Application No. 10/544,120
Paper Dated: May 6, 2009
In Reply to USPTO Correspondence of February 6, 2009
Attorney Docket No. 0388-051649

REMARKS

FIG.5

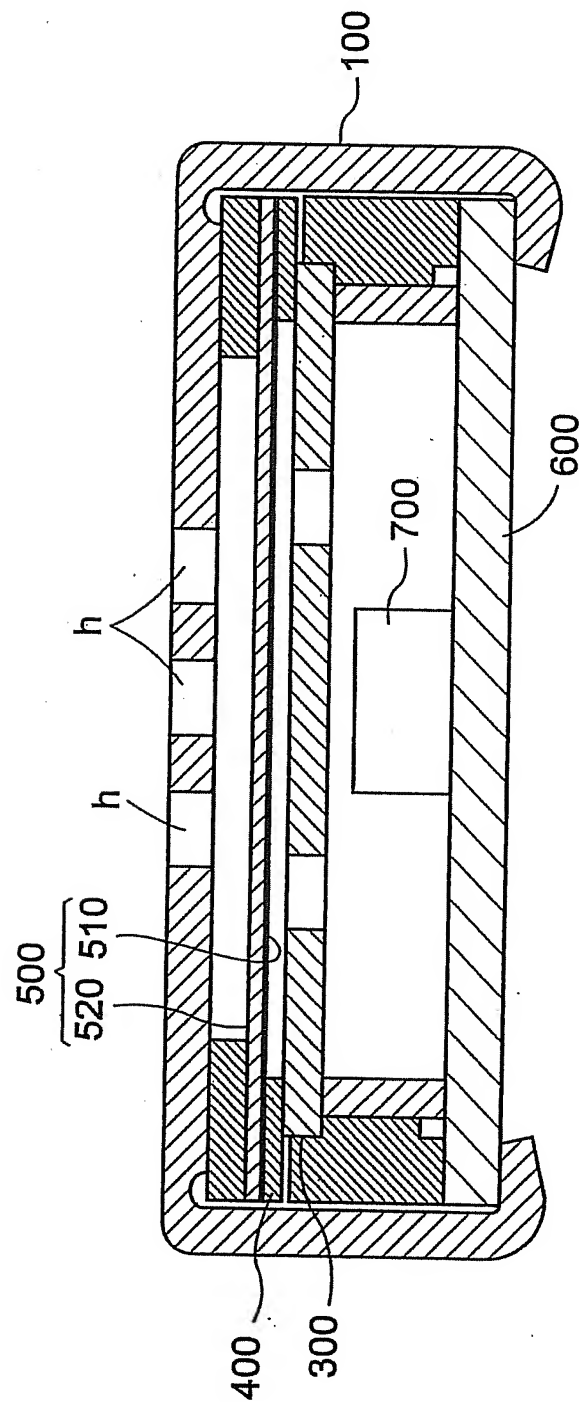
The Examiner has objected to Fig. 5 for not including a designation of "Prior Art." Fig. 5 has been amended to include a designation of "Prior Art."

(PRIOR ART)
